TABLE OF CHANGES FOR PLANNING
AMMENDMENTS: SECTIONS & ELEVATIONS

Project Title
T2 VITA LIVING, ST. JOHNS

Drawing Title
PROPOSED SECTION AA

Drawing Number
6555-P-B500-S-AA

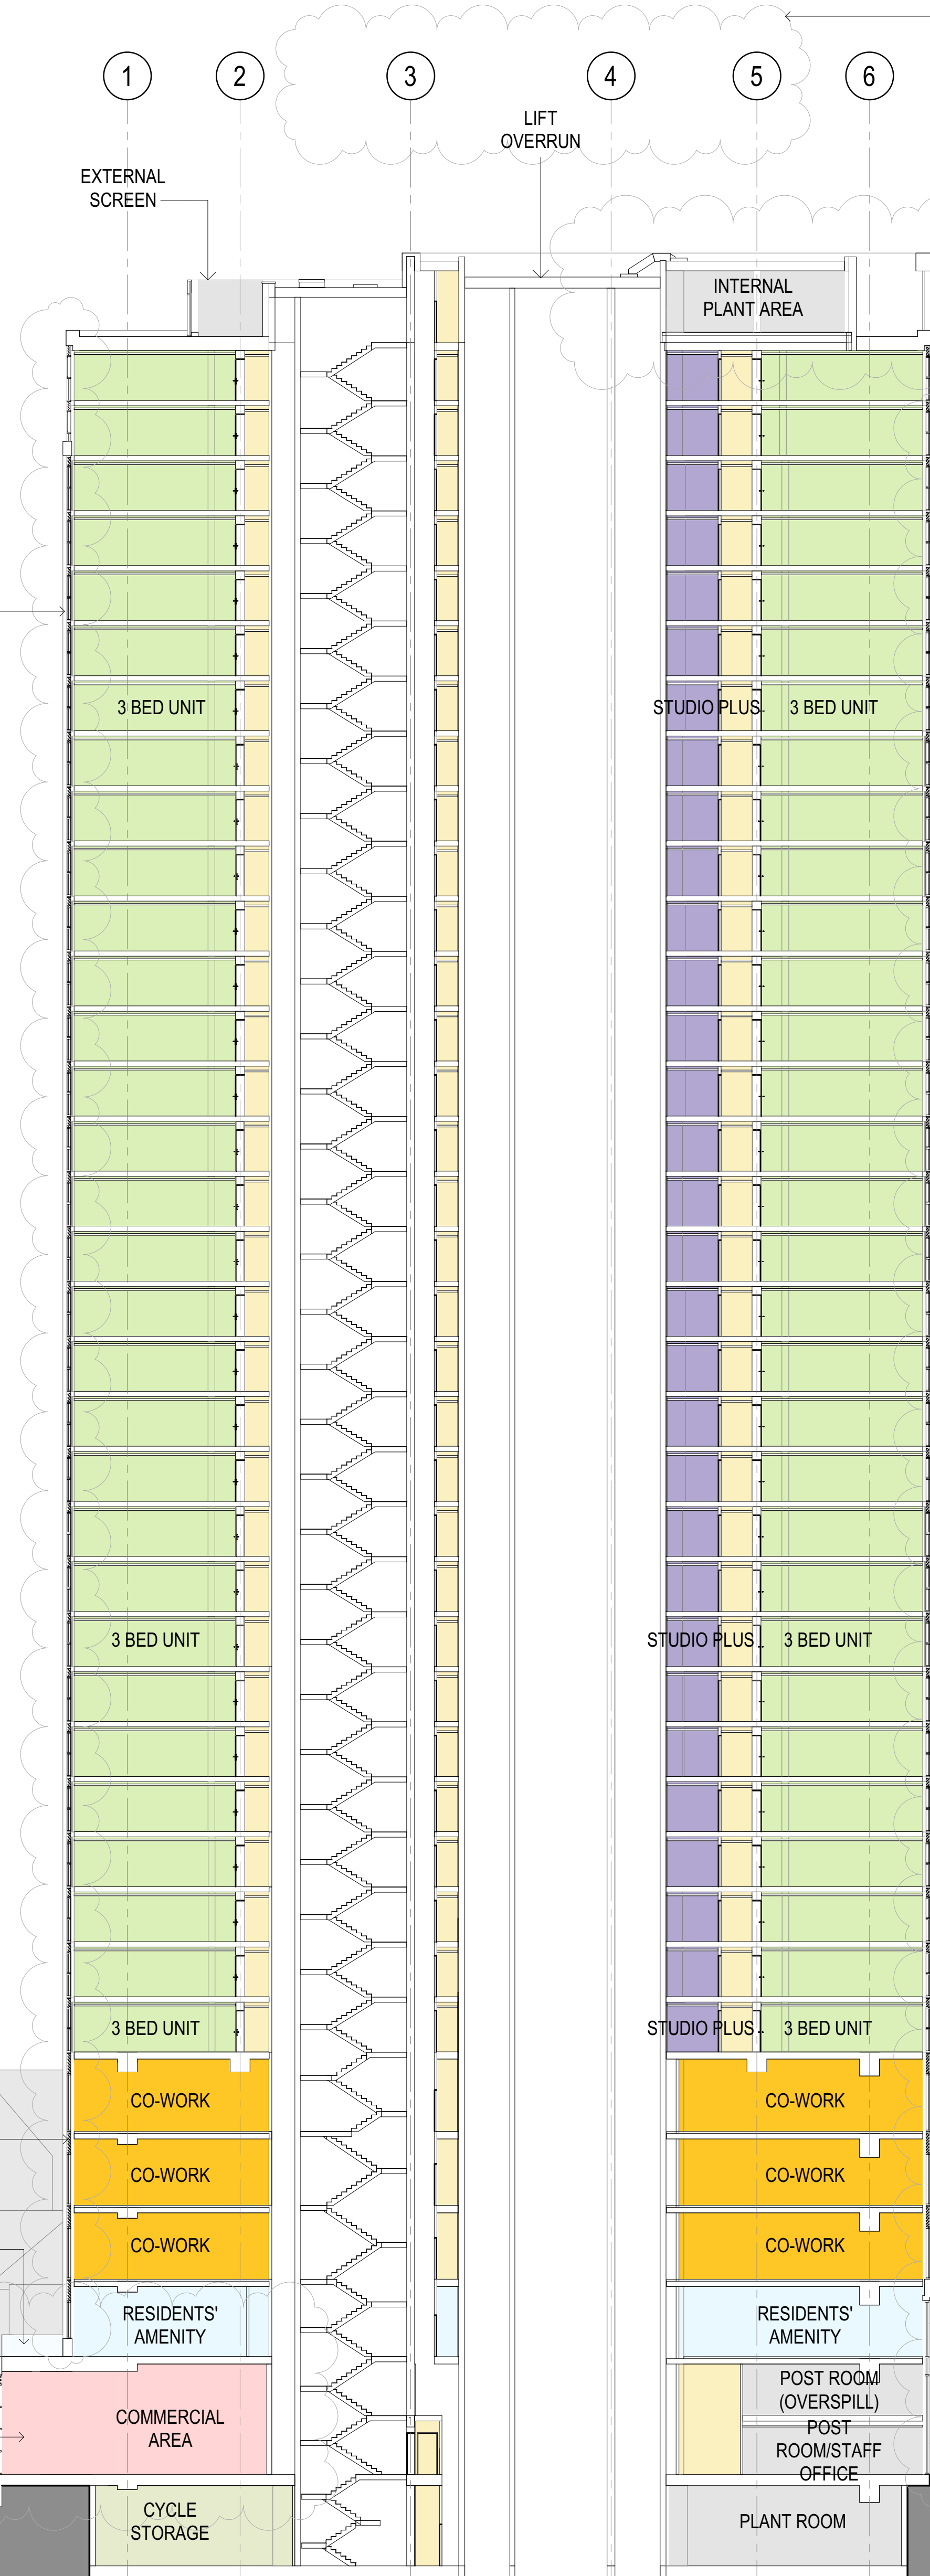
ITEM 5 BMU AMENDED
REFER TO TABLE OF
CHANGES

ITEM 3 CROWN HEIGHT
REFER TO TABLE OF
CHANGES

ITEM 4 APARTMENT
WINDOWS
REFER TO TABLE OF
CHANGES

ITEM 6 SPANDREL
PANELS OMITTED
REFER TO TABLE OF
CHANGES

ITEM 2 ROOF TOP
TERRACE
REFER TO TABLE OF
CHANGES

ITEM 1 GROUND FLOOR
COMMERCIAL UNIT
REFER TO TABLE OF
CHANGES

- 1 - GROUND FLOOR COMMERCIAL UNIT**
GROUND FLOOR FOOTPRINT DEVELOPED TO INCLUDE
COMMERCIAL UNIT
- 2 - ROOF TERRACE**
INTRODUCED AT LEVEL 01 WITH GLAZED
PERIMETER BALUSTRADE

- 3 - CROWN HEIGHT**
HEIGHT OF CROWN REDUCED BY 1.31M
OVEREALL BUILDING HEIGHT REDUCED TO 112M
- 4 - APARTMENT WINDOWS**
SIZE / CONFIGURATION OF APARTMENT WINDOWS
TO RESIDENTIAL FLOORS AMENDED

- 5 - BMU AMENDED**
STATIC ROOF-MOUNTED MAINTENANCE UNIT (BMU)
AMENDED TO MOBILE PERIMETER TRACK-MOUNTED
TYPE BMU WHICH WHEN PARKED IS FULLY
CONCEALED
- 6 - SPANDREL PANELS OMITTED AT LEVEL 01-04**
FIXED GLAZED SPANDREL PANELS TO BOTTOM OF
LEVEL 01-04 GLAZED SCREENS OMITTED TO NOW MAKE
THE SCREENS FULL HEIGHT
